Project	IEEE 802.16 Broadband Wireless Access Working Group < http://ieee802.org/16 >	
Title	CTS allocation for IBS and OBS	
Date Submitted	2006-02-28	
Source(s)	Wu Xuyong, Zhao Quanbo, Pan Zhong, Huawei Huawei Industrial Base, Bantian, Longgang, Shenzhen 518129 P.R.C	Voice: +86-755-28971677 Fax: +86-755-28975523 wuxuyong@huawei.com
Re:	80216h-06_005: Call for Comments and Contributions: IEEE 802.16 License-Exempt Task Group (2006-02-06)	
Abstract	ICTS is for the BSs which does not have repetitive scheduled CTS. OCTS is periodical scheduled to the BSs in community. This paper is discussion the usage, timing and scheduling method of these CTS.	
Purpose	Define the scheduling process and parameter of CTS in one community.	
Notice	This document has been prepared to assist IEEE 802.16. It is offered as a basis for discussion and is not binding on the contributing individual(s) or organization(s). The material in this document is subject to change in form and content after further study. The contributor(s) reserve(s) the right to add, amend or withdraw material contained herein.

CTS allocation for IBS and OBS

Huawei Technologies Co., Ltd.

figure hxx. format of ICTS/OCTS allocation MAP

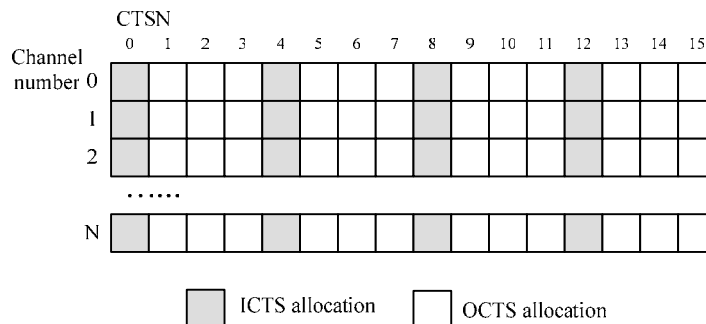
Change section 15.3.1.1.1 as indicate:

Downlink CTS is use by the BSs to broadcast signaling to the neighbor systems. These signals is used for Interference identification and resolution. In order not to collide with the neighbor, the coordinated community should prevent neighbor BSs to use the same CTS.

*CTSN is used to schedule the CTS in neighborhood, CTSN is periodical synchronized number of CTS. The period of CTSN is the length of OCTS cycle. $CTSN = FN(\text{frame number of the frame after CTS}) / N_{CTSimm} \text{ mod}(N_{ICTS_Cycle} * N_{OCTS_Cycle})$*

There was one ICTS for IBS in an ICTS cycle, and the rest CTS is leave to OBS as OCTS. Every OBS need to get its OCTS allocation in one OCTS cycle, which is formed by multiple ICTS cycle so that IBS can get more opportunity then OBS.

*There is N_{OCTS_Cycle} ICTSs in one OCTS cycle, and the rest CTS could be allocated to $((N_{ICTS_Cycle} - 1) * N_{OCTS_Cycle})$ OBSs. Notice if there is N channel which could be used for 16h system in one area. There will be $N * ((N_{ICTS_Cycle} - 1) * N_{OCTS_Cycle})$ OCTS opportunity for OBSs.*

figure 2. example of CTS allocation MAP in one BS's database

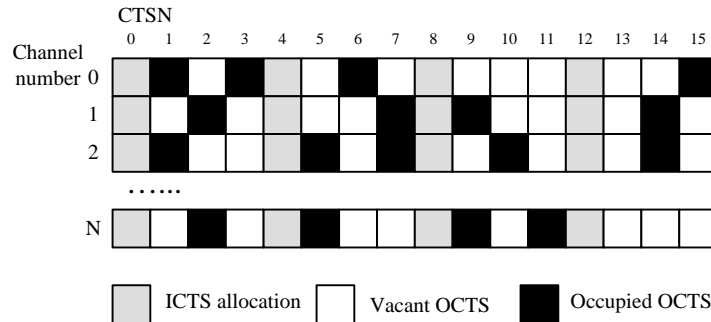
Here is an example of the CTS allocation MAP of one BS during his initialization phase by collecting the CP message information from his neighbors. Assume this BS have choose channel 0 as its working channel, it can pick any one of the CTSN 2,5,7,9,10,11,13,14 as its OCTS allocation number. Every BS have its own CTS allocation map indicating the current situation of CTS occupancy by the neighbors in the working channel and potential neighbors in the potential working channel. The CTS allocation MAP table of potential working channel will be used when BS move to another channel in cases. The CTS allocation MAP of the BS should be updated in time when any changes have been informed by its neighbors in the working channel and potential neighbors in the potential working channel.

In the OCTS mapping table, every neighbor in working channel or potential neighbor in potential channel is mapped to one OCTS allocation, every OCTS allocation will indicate its occupant or vacancy. By inquiring the mapping table of the OCTS allocations to the BSs, one BS can recognize the source of the interference or signaling in each OCTS allocation.

The initializing BS use the OCTS allocation table to find out its neighbors in the working channel. By the contact information it acquired from the CP message, the IBS will than use CP message to negotiate for interference resolution with its neighbors.

Figure h9—Timing of Coexistence Time Slot

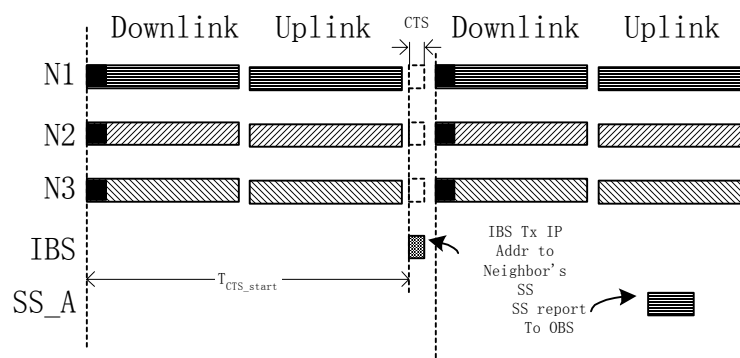
Change the section 15.2.1.1.3 as indicate:

~~ICTS must not be used for other purpose by all the BSs, so that it will be an interference free slot for the coexistence neighbor discovery purpose. Initializing BS (IBS) shall use this slot to broadcast its IP identifier, by sending a message and/or by cognitive radio signaling, so that the coexistence neighbor operating BS (OBS) could find the new coexistence neighbor in IP network after the SS report the message. Then the IBS and OBS begin further negotiation for coexistence protocol. After coordination with the neighbors in the community, IBS will get periodical interference free OCTSs, and become OBS, after that, it will cease to use the ICTS.~~

Not to break the downlink PDU, and to ~~prevent diminish~~ overhead of more preamble and gaps. CTS slots shall be located before RTG/TTG in TTD frame structure or before the preamble of downlink frame in FDD frame structure .To unify the location in these two kind of ~~frame duplexing frame~~, CTS slots in FDD frame shall be put into the downlink structure right before the preamble, and shall be located right before RTG in TDD frame.

~~The IBS_IPBC broadcasting procedure is unidirectional, only from the IBS to the SSs in IBS/OBS's common coverage, and the SSs shall report all the useful information to their OBSs they registered to. The SSs that succeed in receiving the message should report the IP address of IBS and the frame number of the starting frame of IBS_IPBC, the SSs failed to received the broadcasting message but got IBS_IPBC like interference in the ICTS should report the error status and the starting frame number of receiving the ICTS interference. By the IBS IP address reported from the SSs, the OBSs will then find the IBS in the IP network, and go further signaling using IP network. And by checking the frame number in the report, OBS need to find out if the SSs that report the error status in IBS_IPBC receiving have got the same interference source, then OBS will update the database and reply to the SSs which send the error report.~~

Figure h12—CTS usage example—IBS broadcast IP address to CoNBR's SS

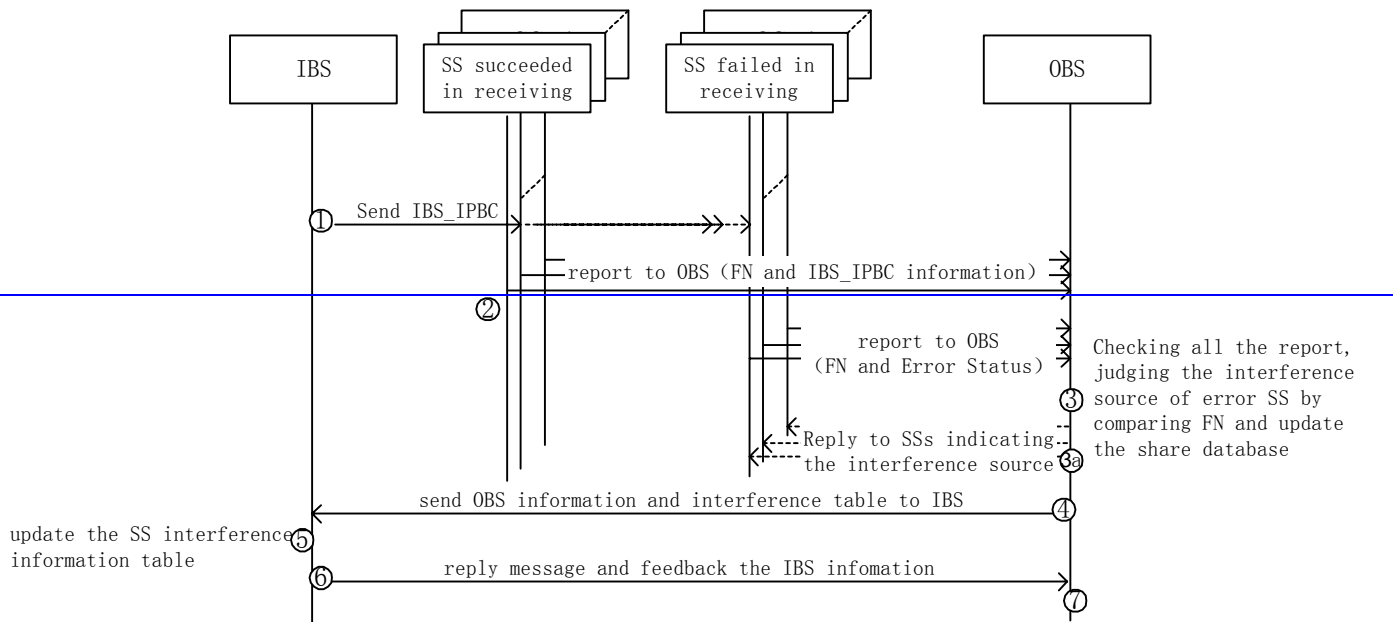
[notes: this figure moves to 15.2.1.3]
